**Economic and Social Council**Distr.: General  
19 August 2011

**Economic Commission for Europe****Inland Transport Committee****World Forum for Harmonization of Vehicle Regulations****155<sup>th</sup> session**

**Global technical regulation (gtr) No. 9 (Pedestrian safety)****Proposal for developing amendments to gtr No. 9 (Pedestrian safety)****Submitted by the representative from the Netherlands\***

"Figure 6A

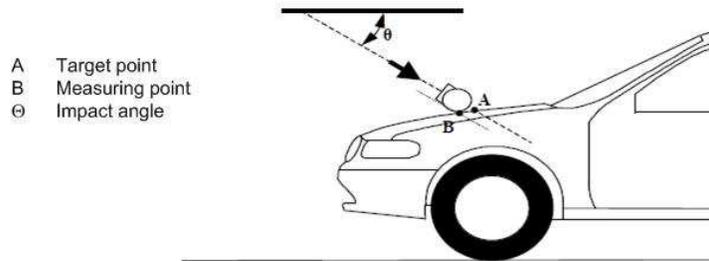
Figure 6, shall be deleted

Insert new Figures 6A to 6C, to read:

**Measuring and target point in the vertical longitudinal plane through the center of the impactor (see paragraphs 3.30. and 3.25.)<sup>2</sup>**

**Measuring and target point**

"3.25. **Target point**" means the intersection of the projection of the headform longitudinal axis with the front surface of the vehicle (see point A in Figure 6A)."

"3.30. **The measuring point for the headform test is a point in the vertical longitudinal plane of the vehicle, containing the centre of the impactor. In this plane, it is the point at which the impactor nominally first contacts the bonnet top (see point B in Figure 6A and Figure 6B). The first contact point may differ from the measuring point as a result of the geometry of the bonnet top.**"

Figure 6B

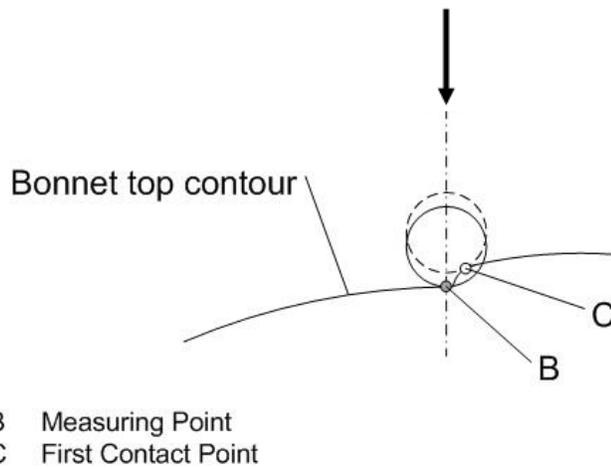
**Measuring and first contact point (see paragraphs 3.30. and 3.19.)<sup>2</sup>**  
(schematic front view)

<sup>2</sup> Remark: due to the spatial geometry of the bonnet top, the first contact point C does, in most cases, not lie in the same vertical longitudinal or transverse plane which contains measuring point B.

"3.19. ~~"Impact~~ **First contact point**" means the point on the vehicle where initial contact by the test impactor occurs. The proximity of this point to the target point is dependent upon both the angle of travel by the test impactor and the contour of the vehicle surface (see point C B in Figure 6B and Figure 6C)."

"Figure 11

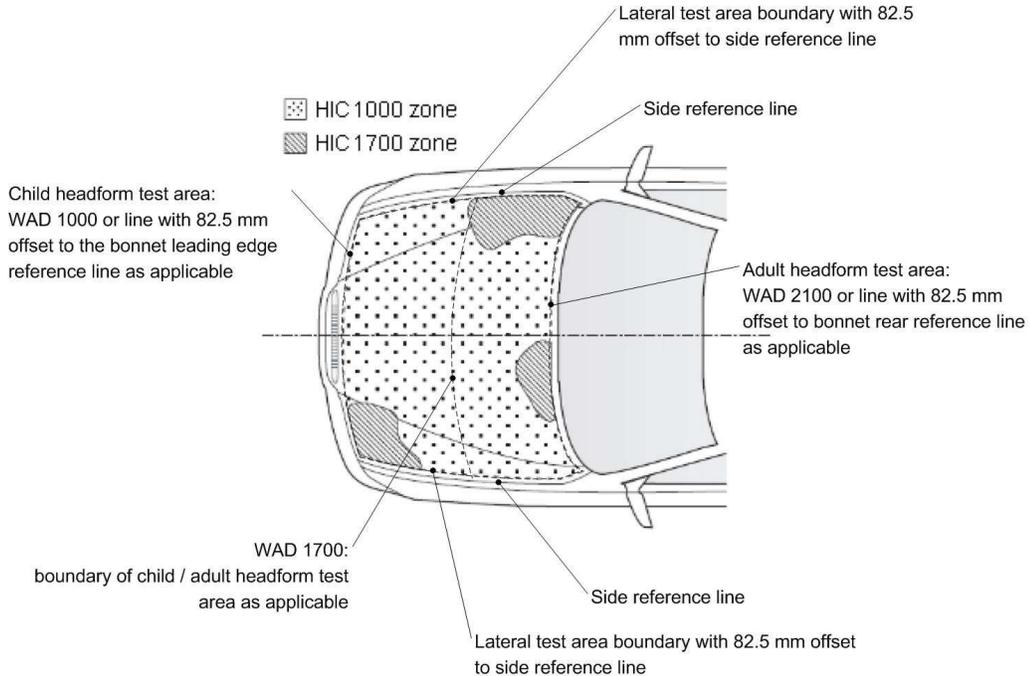
Figure 11(former), shall be deleted

Insert new Figure 11, to read:

**Example of marking of HIC1000 zone and HIC1700 zone**

"5.2.4.1. The manufacturer shall identify the zones of the bonnet top **test area** where the HIC must not exceed 1,000 (HIC1000 Zone) or 1,700 (HIC1700 Zone) (see Figure 11)"
